22/02154/FUL | Rear extension with associated internal reconfiguration and works to external front and rear trade areas including new fence and double gate. | Foresters Arms Village Road Kirdford West Sussex RH14 0ND

Please find enclosed our representations to the planning application 22/02154/FUL (Foresters Arms, Village Road, Kirdford) prepared on behalf of Kirdford Parish Council.

Figure 2: Proposed West Elevation (indicating close board fence)

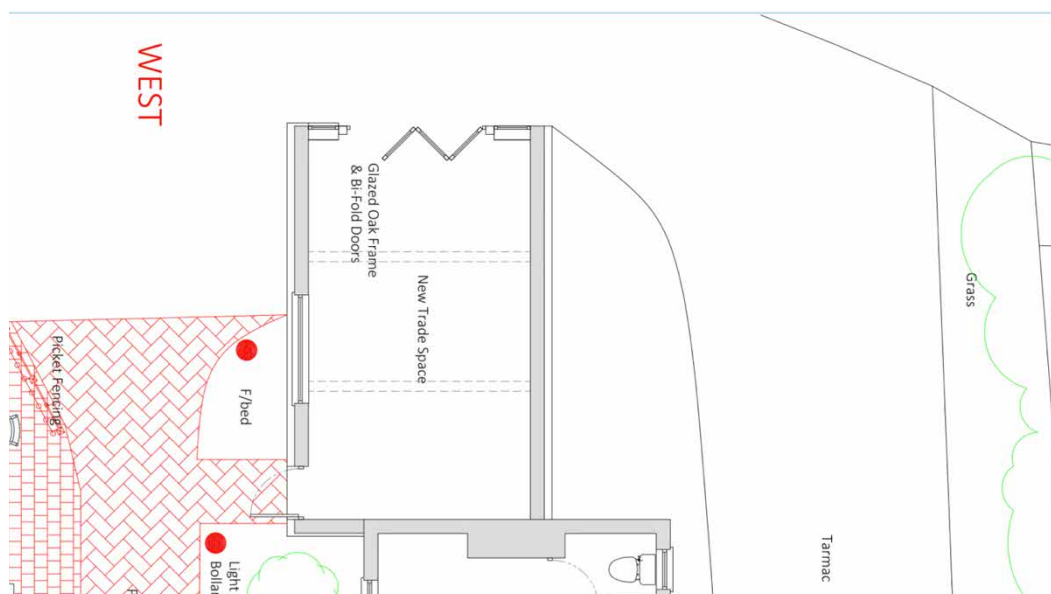
From the plans and elevations submitted by the Applicant it is unclear what it is proposing regarding the close board fence proposed at the northwest of the site. Based on the 'West Elevation' drawings the fence appears to extend beyond the application boundary and into the lane located to the north (see Figures 2 and 3 below). KPC questions whether this proposed fence would prevent access to the lane as well. The fence is not indicated on the 'Layout Plan' therefore KPC is unable to confirm the details of this proposal and requests that the Applicant provides a full set of drawings, measurements and explanation in relation to the fence.

A large close board fence is proposed on the west elevation which is not appropriate to face onto the public realm, especially on the frontage of the listed building. A close board fence of this style will prevent wildlife movement. A small wall (with integrated hedgehog holes) with hedge planting may be more aesthetically attractive as a boundary treatment. See Figure
